Rodeo Renewed Project

Final Environmental Impact Report

County File No.
CDLP20-02040

March 2022

Figures 3-1 and 3-2 are replaced with the following.

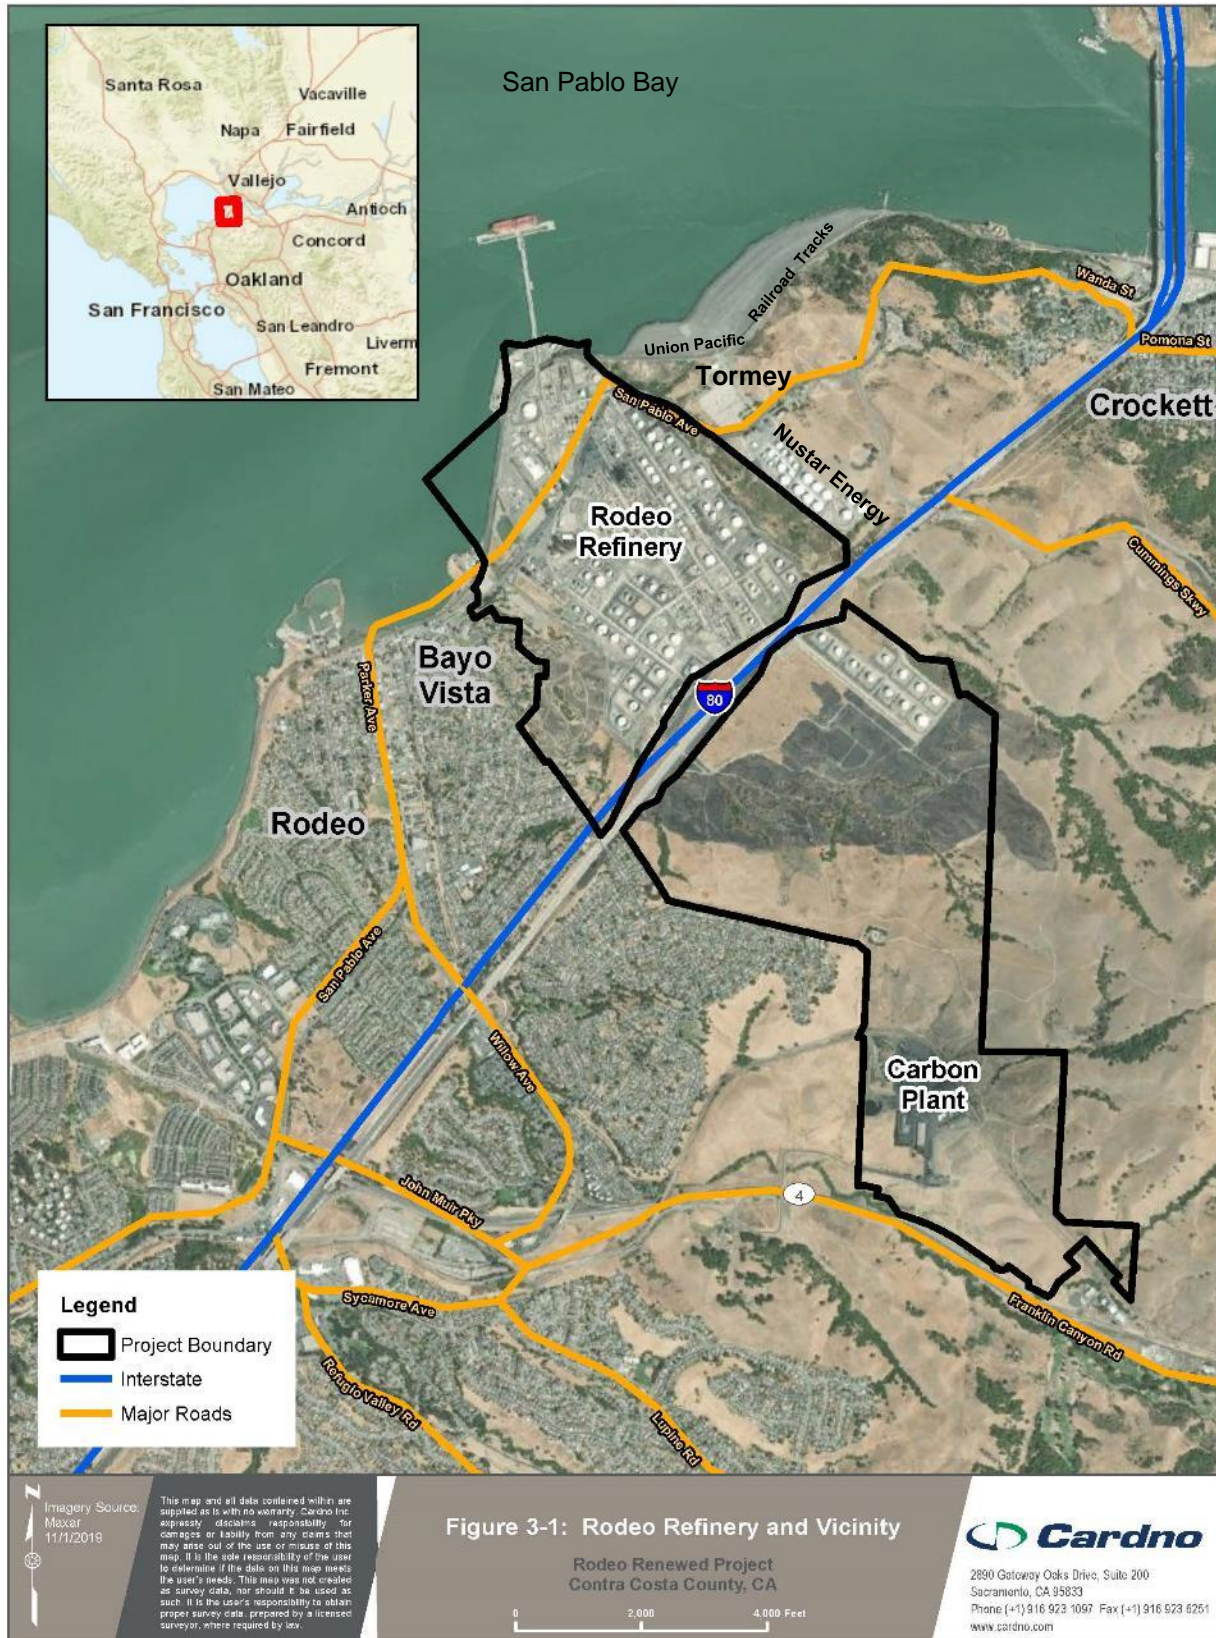
Figure 3-1, *Rodeo Refinery and Vicinity* indicates the Project boundary with a solid black line. This boundary shows a triangular shaped inclusion on the east side that encompasses a portion of submerged and therefore sovereign lands. This area does not appear to be included in the existing Commission lease. What is the purpose of including that aquatic area inside the Project boundary? What activities will take place specifically in that area?

The solid black line boundary on Draft EIR Figure 3-1 shows the approximate property boundary of the Rodeo Refinery. As described in the Draft EIR, Project activities will occur within a portion of the Rodeo Refinery property boundary. No Project activities will occur within the triangular-shaped inclusion on the

Figures 3-1 and 3-2 have been revised to show the locations of adjacent facilities (e.g. San Pablo Bay, NuStar Energy tank farm, Tormey, Union Pacific/Amtrak railroad).

Figure 3-5: Pipeline Sites

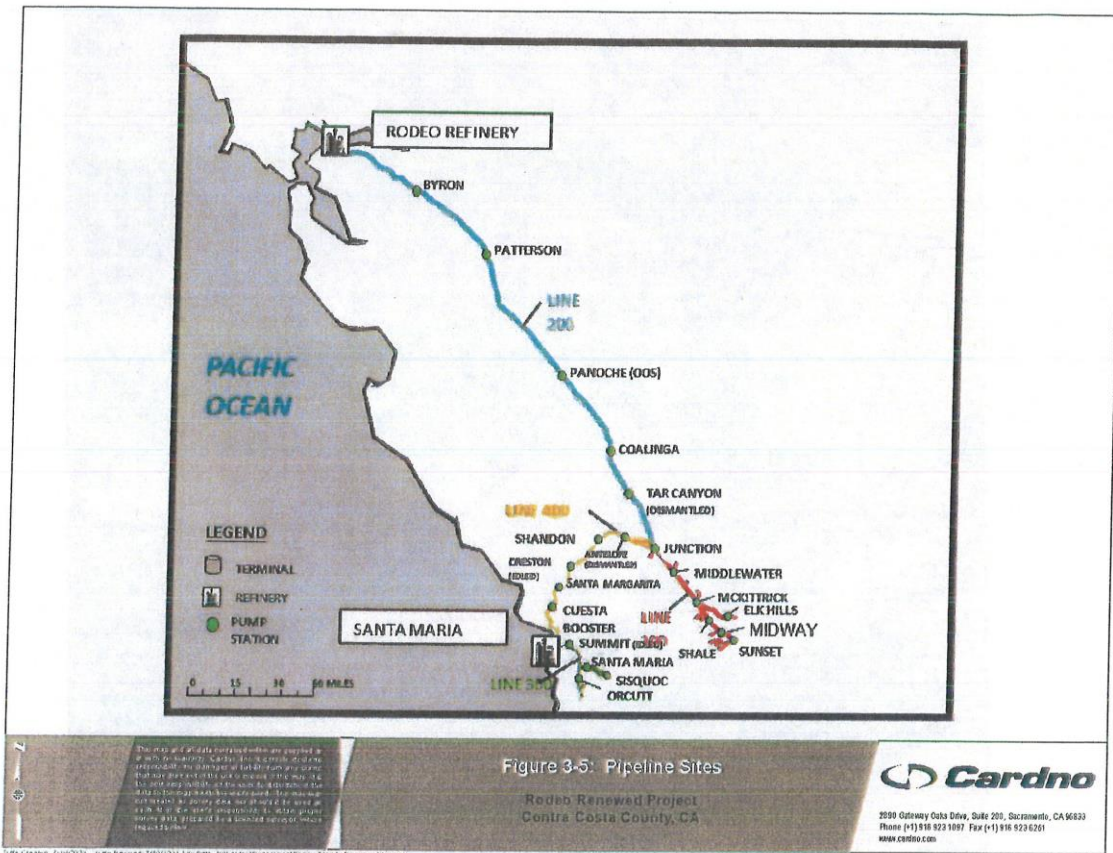
⁵² Karras, 2021c. Careful review of DEIR Figure 3-5 confirms this accurate description of pipeline flows, once the reader knows that crude does not flow to the SMF through Line 200. However, the erroneous assertion in the text on page 3-21 of the DEIR is misleading on that point because it could only make sense by assuming the opposite.

As noted in the excerpt provided above, these are depicted in four figures, including Draft EIR Figure 3-5, Pipeline Sites, which depicts the locations of Lines 100, 200, 300 and 400.

The Project includes the Pipeline Sites—four regional pipelines serving the Santa Maria Site and the Rodeo Refinery. The Santa Maria Site is connected to the Rodeo Refinery by approximately 200 miles of subterranean pipeline (Figure 3-5), designated Line 400 and Line 200. Line 400 runs north and east from the Santa Maria Site through the Coastal Range of central California in San Luis Obispo and Kern Counties, a region of dry grassland, pasture, and open live oak woodland, to connect with Line 200 north of McKittrick. Line 200 runs northwest up the west side of the San Joaquin Valley, through a mixture of Coastal Range grasslands and pasture and San Joaquin Valley agricultural land, and then west to the Rodeo Refinery. Line 200 runs through Kern, Kings, Fresno, Merced, Stanislaus, San Joaquin, Alameda, and Contra Costa Counties. ~~Two other pipelines—Line 100 and Line 300—connect the Santa Maria Site to crude oil collection facilities elsewhere in California (Figure 3-5). Line 100 runs underneath San Joaquin Valley agricultural land and Coastal Range grasslands and pasture lands in Kern County, and Line 300 runs beneath agricultural land and grasslands in the Santa Maria Valley area in San Luis Obispo and Santa Barbara Counties.~~ Line 100 is used to transport crude oil from several collection facilities in Central California to Line 200 at the Junction Pump Station. Line 100 runs underneath San Joaquin Valley agricultural land and Coastal Range grasslands and pasture lands in Kern County (Figure 3-5). Line 300 connects crude oil collection facilities elsewhere in California to the Santa Maria Site and runs beneath agricultural land and grasslands in the Santa Maria Valley area in San Luis Obispo and Santa Barbara counties (Figure 3-5).
